From: Joseph Swift
Sent: 04 April 2025 15:37:39 UTC+01:00
To: "Mark Thomas" <mthomasesq@outlook.com>
Cc: "Richard Thompson" <rthompson@hadronconsulting.co.uk>
Subject: RE: DM/25/0091

RE: Discharge of Condition 6 in regards to DM/23/3182.

AT: Burgess Hill Northern Arc, Land North And North West Of Burgess Hill, Between Bedelands Nature Reserve In The East And, Goddard's Green Waste Water Treatment Works In The West

REFERENCE: DM/25/0091

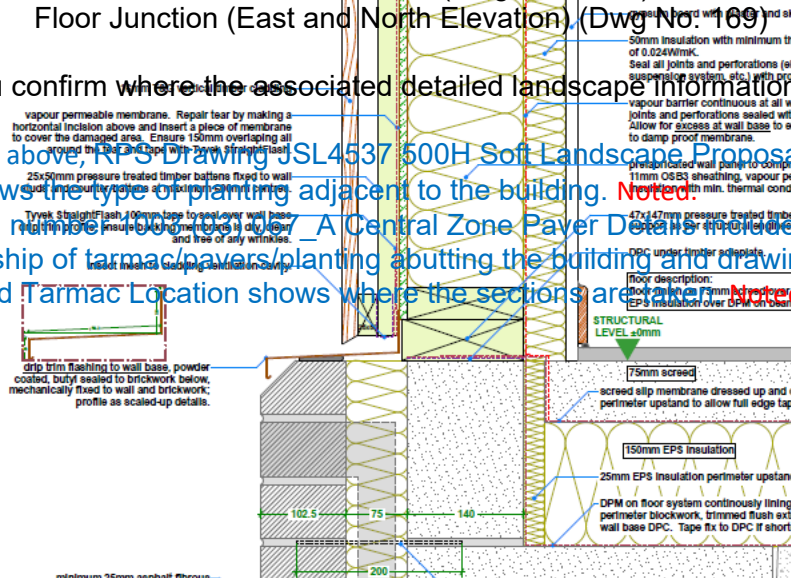
Thank you for sending through the key, from looking at the plan it appears that the following plan is incorrect:

- GA Floor Details (Dwg No. 108) – Shows asphalt when this would be landscaping. **dwg 108 is still showing paving coming directly onto the building instead of landscaping.**

The detail prepared by TGE is indicative and the external landscape proposals show for specific finishes and planting. Please refer to RPS Drawing JSL4537 500H Soft Landscape Proposals and Enclosures Plan 1 of 2 for the details of planting adjacent to the pavilion building. Other TGE drawings show the relationship of the building to the surround and finishes are either planting, tarmac or pavers. **Noted.**

Drawing number 1003 (03) 061_E Coloured Tarmac Location shows the additional planting area that about the football 3G pitch fence requested by Anna. **Noted.**

- Materials – Equipment (Dwg No. 162).

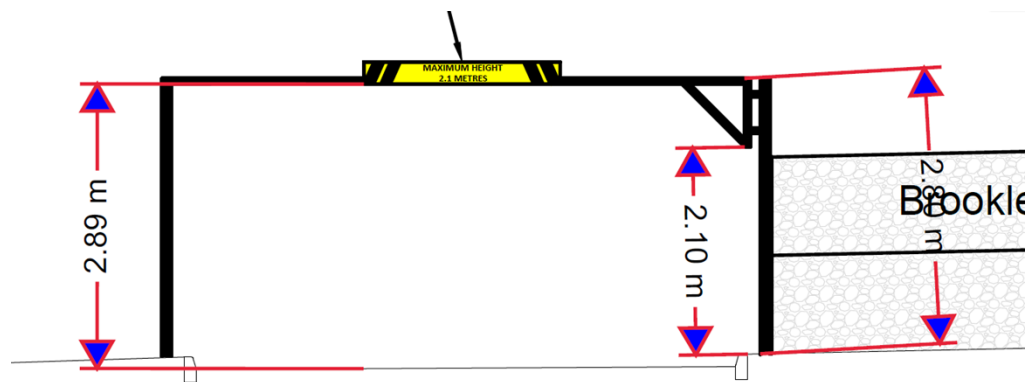
The plans show the typical internal unit, this appears to be domestic extractor fan, very little information has been provided regarding the air movement within the building, particularly with respect to ventilation in the toilets and shower rooms, which is essential to prevent issues with odours and moisture. The extraction rates should be designed in line with the rating of the rooms following the CIBSE Guidance. Do we have details of the designed system? A domestic extraction unit is not considered to be suitable for the intended use within a commercial building and as such it is not considered that this would be the typical unit.

Please refer Designphase drawing Ventilation Drawing 811RevJ.pdf prepared on behalf of the Contractor showing the ventilation layout including supply, extract, and heat recovery. The Contractor has advised the following in relation to design and the Approved Inspector will be required to sign-off Building Regulations compliance.

In relation to Burgess Hill I have consulted with our mechanical engineer, who has confirmed that the Ventilation System was based on a mechanical ventilation strategy in accordance with Building Regulation Part F2. Additionally, all equipment selected is suitable for a commercial environment.
